TROJAN NUCLEAR PLANT

Operating License NPF-1  
Docket 50-344  
License Change Application 55

LICENSE CHANGE APPLICATION 55

Figure 6.2-1 Offsite Organization for Facility Management and Technical Support

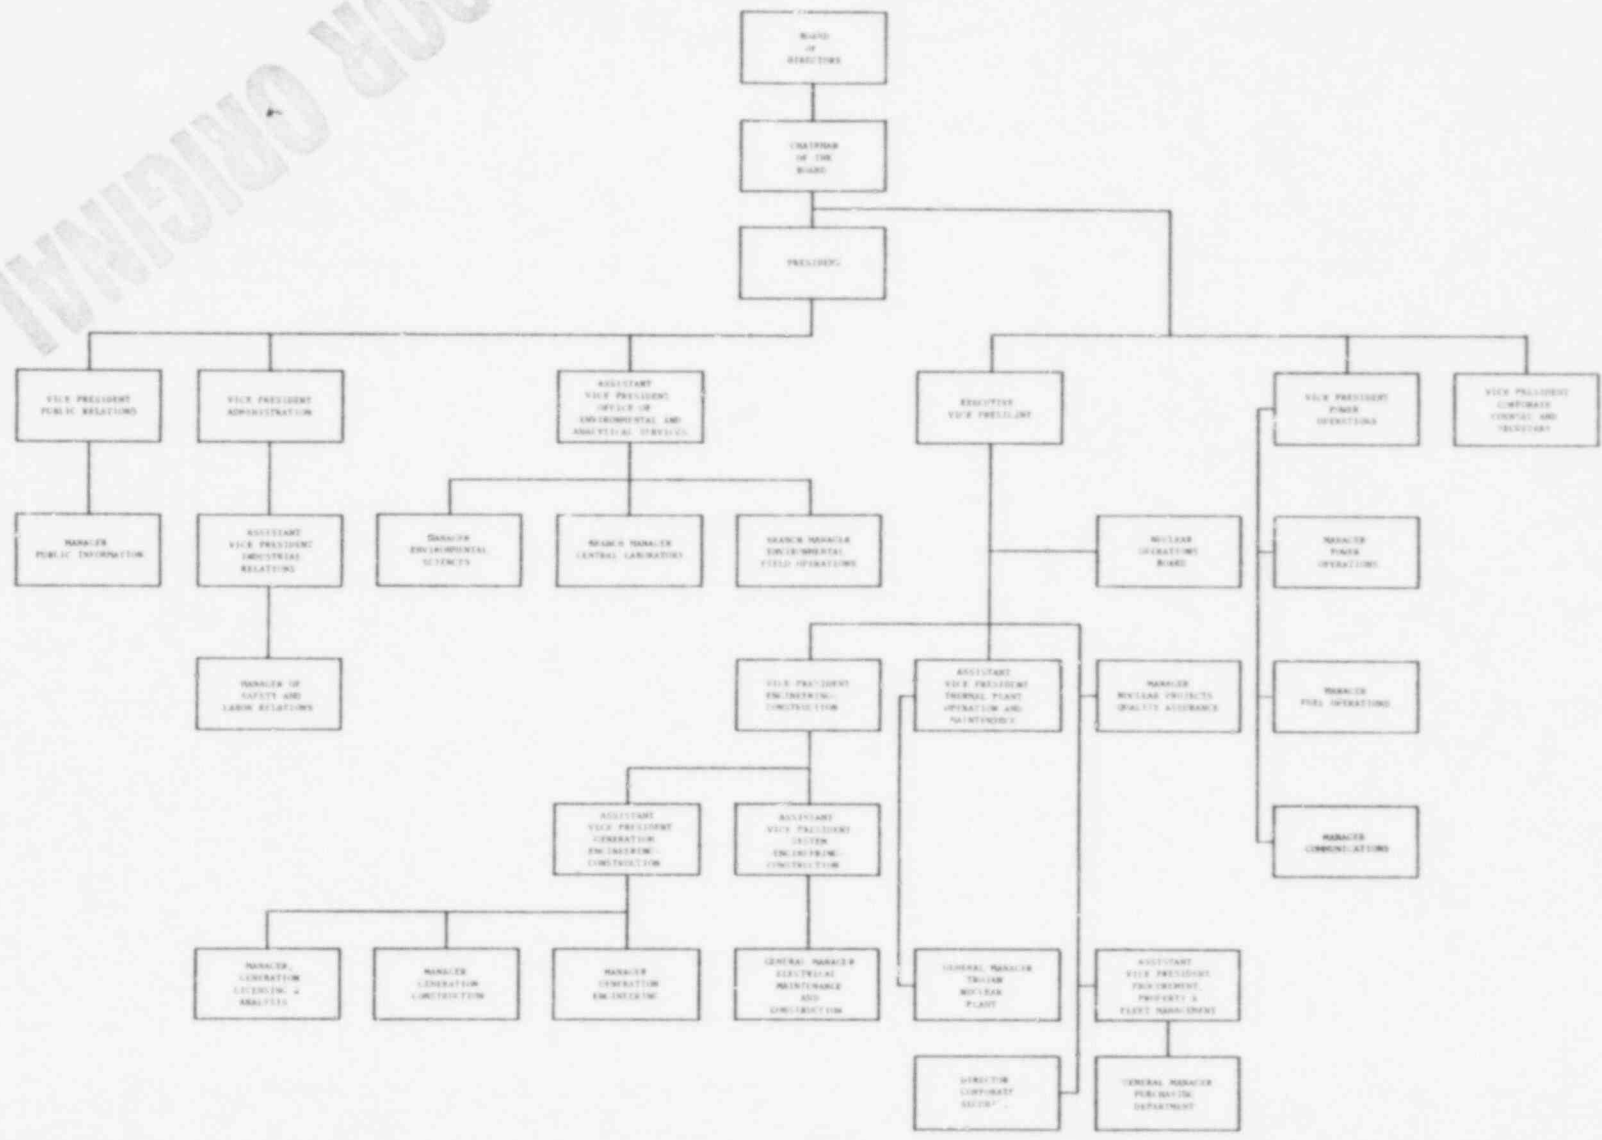
1. Specification 6.1.1. (Page 6-1): Change "Plant Superintendent" to "General Manager".
2. Replace Figure 6.2-1 (Page 6-2) of Appendix A and Figure 5.1 (Page 5-9) of Appendix B with new figures as provided in Attachment A which reflect changes in PGE's corporate organization described under "Reason for Change" below.

The change in PGE corporate organization is primarily one of title changes and the reporting relationships of certain positions. Only two new positions are created in direct support of Plant operations. These changes are explained as follows:

- 1. Environmental Sciences and the Analytical Laboratory Departments have been combined into one division managed by the Assistant Vice President, Office of Environmental and Analytical Services.
- 2. The PGE Purchasing Department is now managed by the General Manager, Purchasing Department, who reports to the Assistant Vice President, Procurement, Property, and Fleet Management.

3. The Chief Nuclear Engineer title has been changed to Manager, Generation Licensing & Analysis, with no change in departmental responsibilities or composition.

4. Nuclear fuel management has been concentrated and assigned to one separate department, headed by the Manager, Fuel Operations, with no change in responsibilities or composition.

5. The position of Director, Corporate Security, was created to manage corporate security and administer nuclear plant security.
6. The position of Trojan Safety Coordinator, reporting to Industrial Relations, was created to be responsible for the Trojan Nuclear Plant Fire Protection Program and other safety programs.
